Memorandum

Re: Proposed amendments to zoning

Date: July 28, 2023

Dimensional Standards Building:

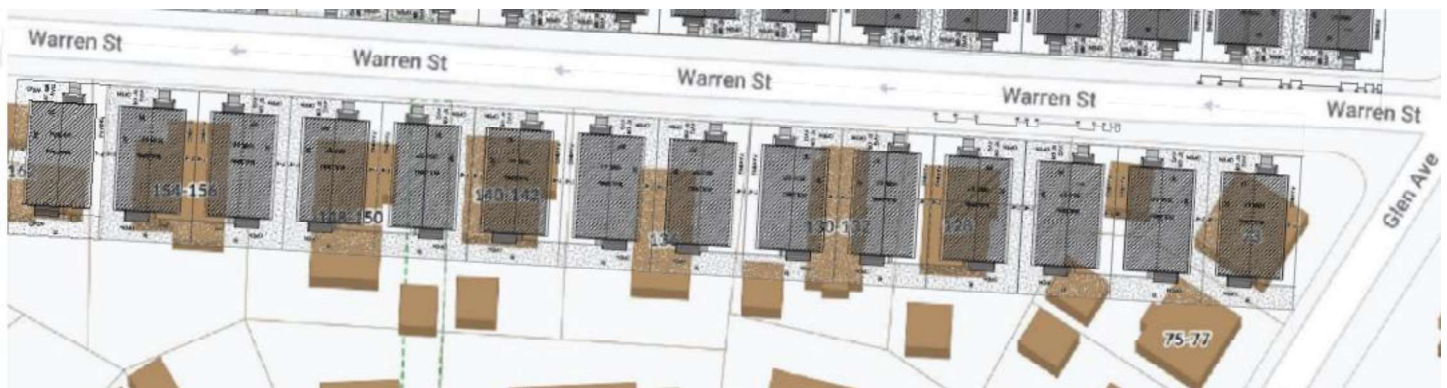
1. Limit VC2 and VC3 developments within 50’ of lot line abutting a residential district to 3.5 stories with the present zoning setback of “½ building height or 15’, whichever is larger”
2. Lower maximum MRT pitched roof height to 40’
3. *I would like a discussion on the active use depth minimum. Is 25’ too large? Would 12’ be OK for a pop up?*
